STAFF REPORT FOR THE PLANNING COMMISSION

FILE NUMBER: MISC-10-14/LLA-10-03

REQUEST: Lot line adjustment and extension of previously approved 289,000 square foot office campus and parking structure near 1870 Blankenship Drive

Figure 4 Location of required parking within 200- (blue circle) and 300-feet (red circle) of main building entrances

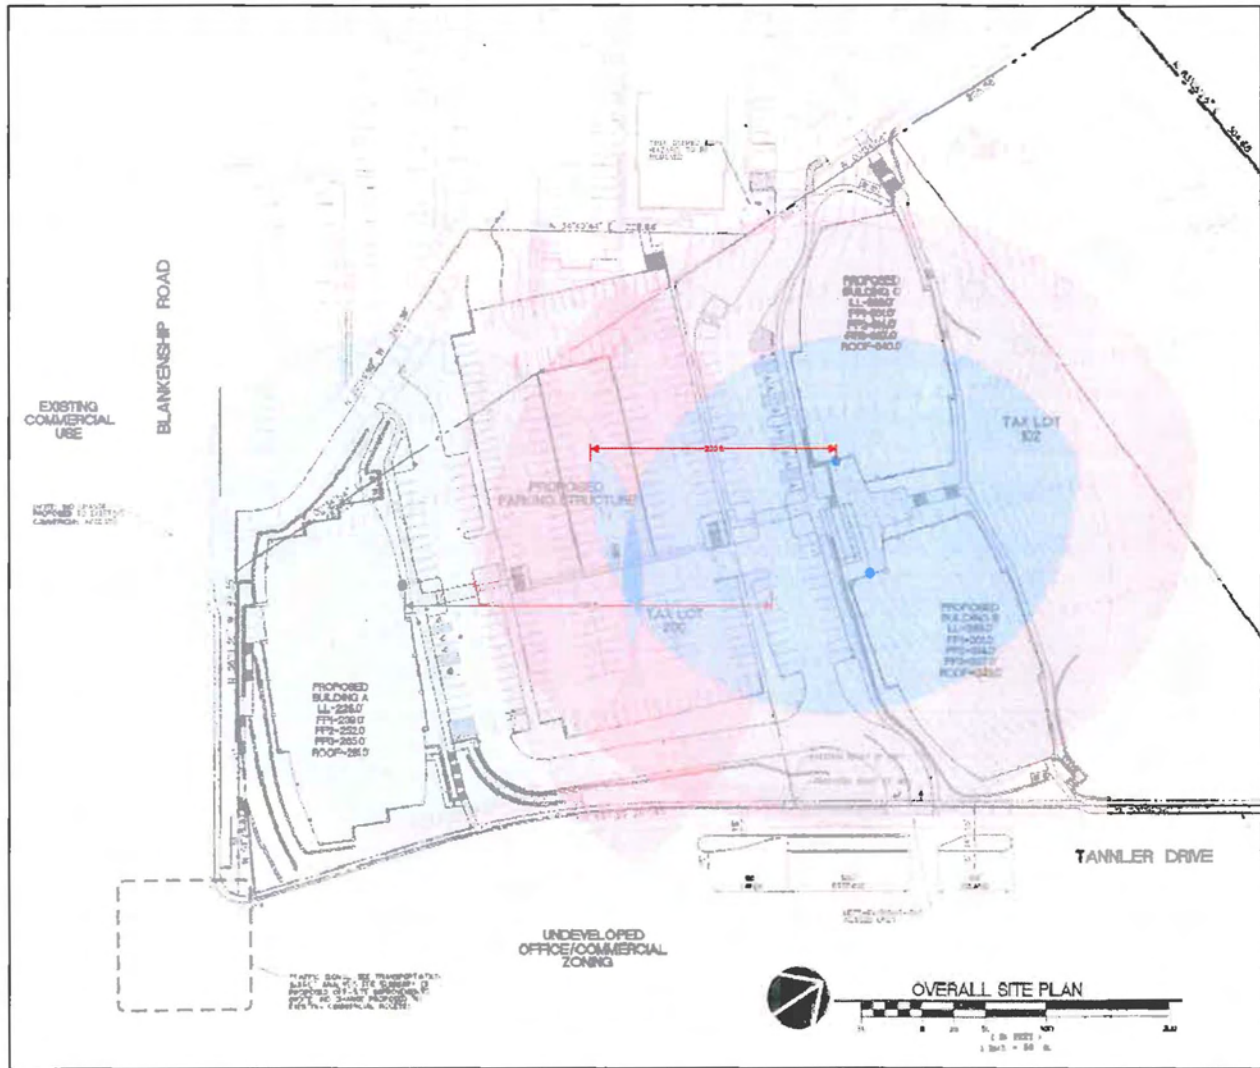
As illustrated in the applicant's submittal and in Figure 4 below, all of the 828 required parking spaces are within 300-feet of the main entrance to each of the buildings they serve. Additionally, 757 parking spaces are within a distance of 200-feet of the main building entrances. Table 2 provides a breakdown of the required parking per building and the amount of parking provided within 200-feet of the three building entrances. The criterion is met.

Figure 5 Access separation of proposed access drives on Tannler Drive

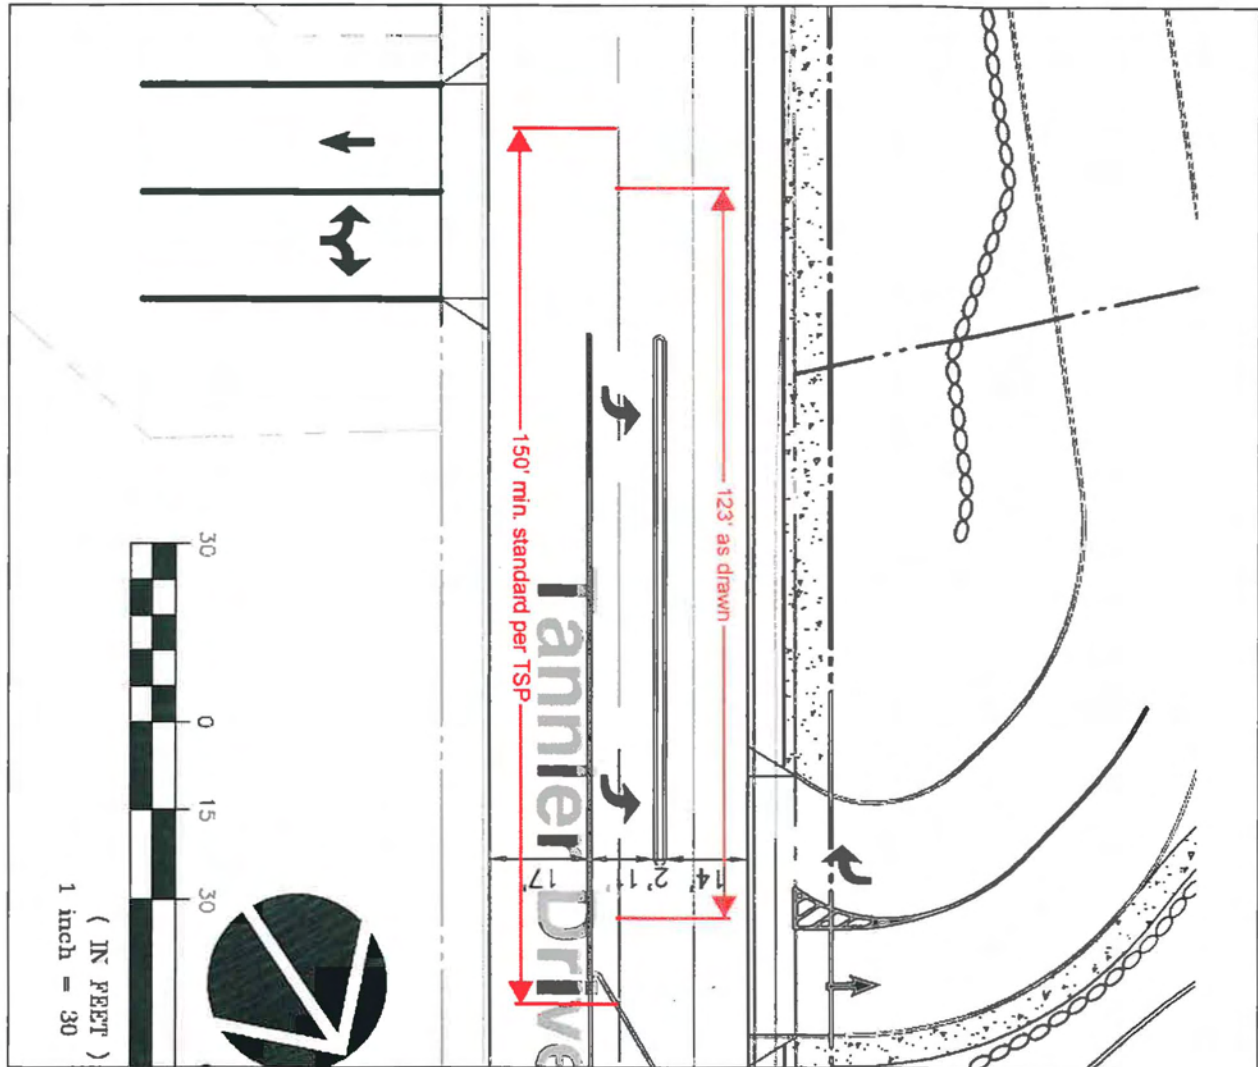
The applicant proposes access to a public street via options 3(b) and (c) above. The applicant's plans show direct access to Tannler Drive at the site's east property line and access to Blankenship Road via a shared driveway with Willamette Corporate Park Phase I. Condition of Approval 2 from AP-07-01 requires that the applicant provide satisfactory legal evidence establishing joint use per Subsection 49.025(B)(3)(b) above. Furthermore, the TSP requires that private driveways accessing collector roadways be spaced at least 150 feet apart.

The proposed driveway onto Tannler Drive would be at least 500 feet from the nearest established intersection. The proposed location of this driveway would not however, allow the Tannler East development to satisfy this standard when that property develops, see Figure 5. Therefore recommended Condition of Approval 5 calls for the applicant to modify the location of the proposed access onto Tannler Drive to accommodate a minimum access separation of 150-feet, as measured from driveway centerline to driveway centerline, between this access and an eventual Tannler East access on Tannler Drive.

5. Access Spacing. The applicant shall modify the location of the proposed access onto Tannler Drive to accommodate a minimum access separation of 150-feet, as measured from driveway centerline to driveway centerline, between this access and an eventual Tannler East access on Tannler Drive. The applicant shall submit these plans with the construction plan package.

Figure 6 Proposed lot line configuration and alternative configuration to satisfy CDC Section 85.210(A)(4)

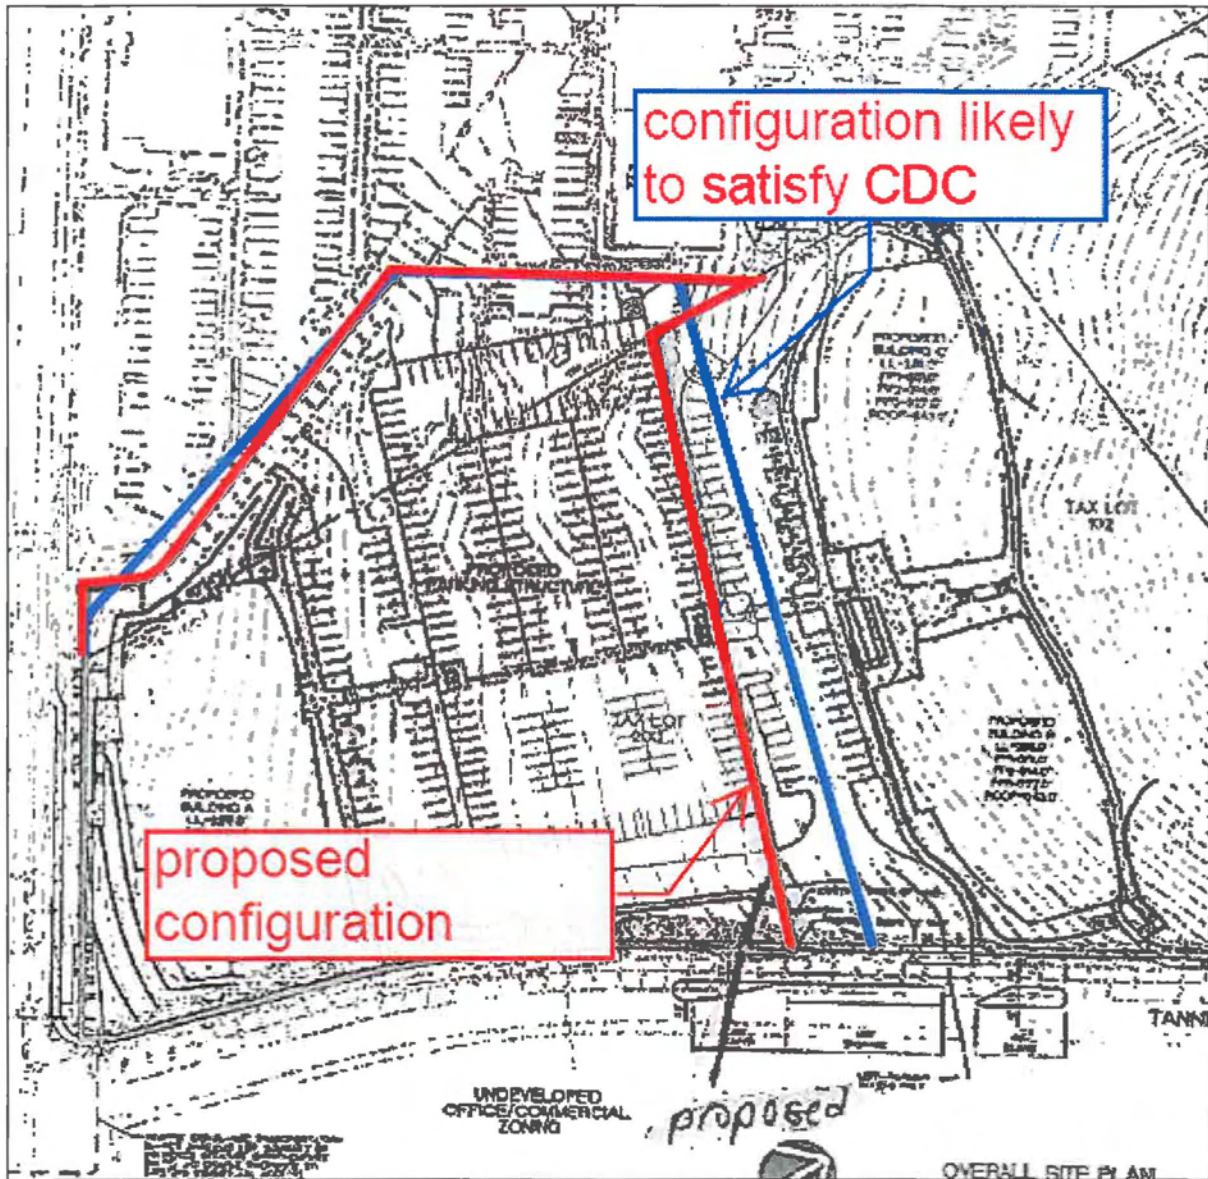
The standard in Subsection (4) above, does provide room for "a few deviations" from generally straight segments. Due to the irregular shape of the resulting lots 801 and 200 however, staff believes the applicant's proposed lot line adjustment most closely approximates the diagram depicting unacceptable lot line adjustments above.

Consequently recommended Condition of Approval 7 calls for the applicant to modify the proposed configuration of lots 801 and 200 to reduce the number of deviations from generally straight segments, while maintaining consistency with the dimensional standards in 85.210(A)(2). Staff believes the applicant can satisfy this criterion with a proposal similar to that illustrated in Figure 6.

OVERALL SITE GRADING PLAN

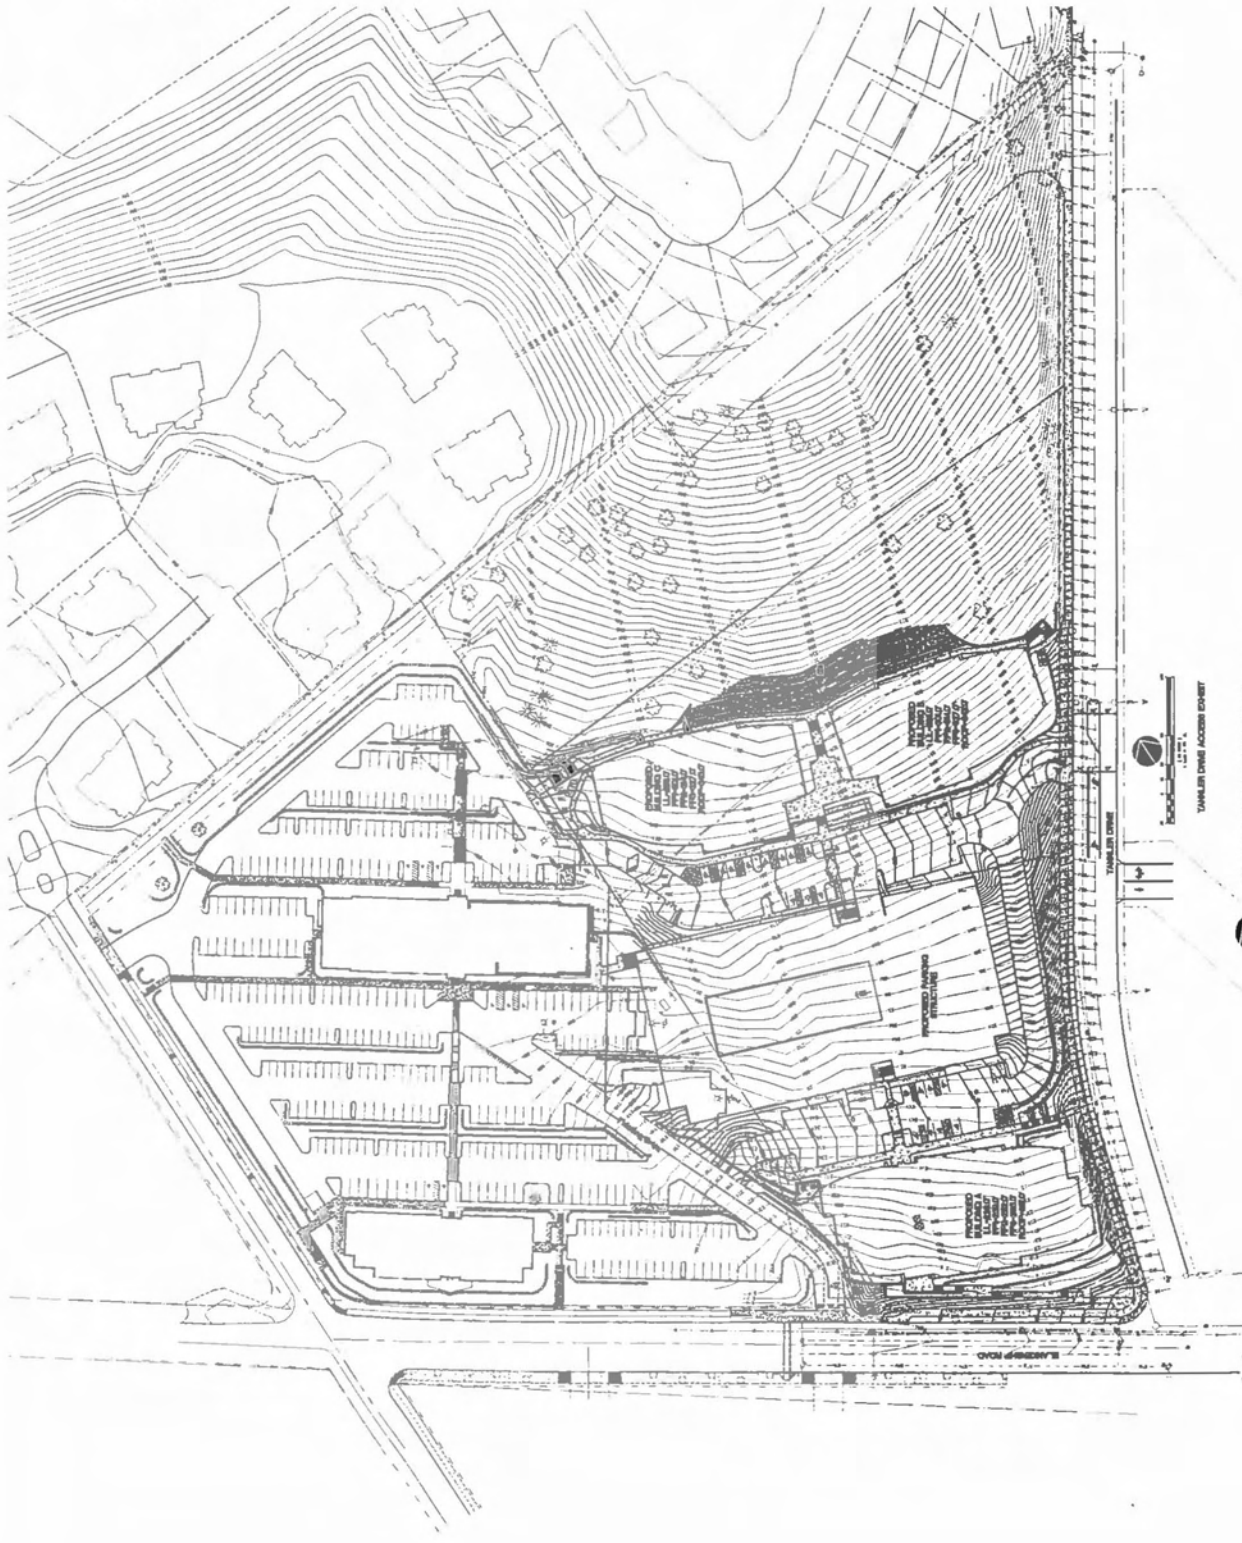
As proposed, all parking areas contain no grade greater than 5 percent. The applicant’s site grading plan (sheet C3.1, Exhibit PC-3) does indicate however, that drainage across a designated walkway is proposed for the walkway connecting the north entrance of Building A with the proposed parking structure. Recommended Condition of Approval 4 calls for the applicant to modify the drainage plan to prevent drainage crossing the designated walkway between the north entrance to proposed Building A and the proposed parking structure.

4. Drainage. Prior to the issuance of grading permits, the applicant shall modify the drainage plan to prevent storm water drainage from crossing the designated walkway between the north entrance to proposed Building A and the proposed parking structure, subject to the City Engineer's approval consistent with Subsection 46.150(A)(17).
